UNITED STATES PATENT AND TRADEMARK OFFICE

APPLICATION NO.	FILING DATE	FIRST NAMED INVENTOR	ATTORNEY DOCKET NO.	CONFIRMATION NO.
10/552,387	10/07/2005	Hideyuki Inose	482782007600	9265
25224 7590 02/12/2008 MORRISON & FOERSTER, LLP 555 WEST FIFTH STREET SUITE 3500 LOS ANGELES, CA 90013-1024				
EXAMINER				
FIELDS, DORON D				
ART UNIT		PAPER NUMBER		
4143				
MAIL DATE		DELIVERY MODE		
02/12/2008		PAPER

Office Action Summary

DETAILED ACTION

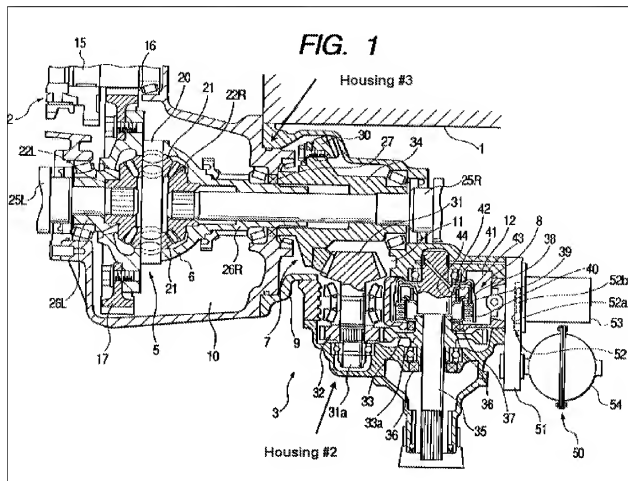
- *the housing member comprises a first housing member, a second housing member and a third housing member* (see at least Fig 1),
- *one of the pair of the first bearings, one of the pair of the second bearings and one of the pair of the third bearings are housed in the first housing member* (see at least Fig 1; entire housing),
- *another of the pair of the first bearings and another of the pair of the second bearings are housed in the second housing member* (see at least modified Fig 1 below) , and
- *another of the pair of the third bearings is housed in the third housing member* (see at least modified Fig 1 below).
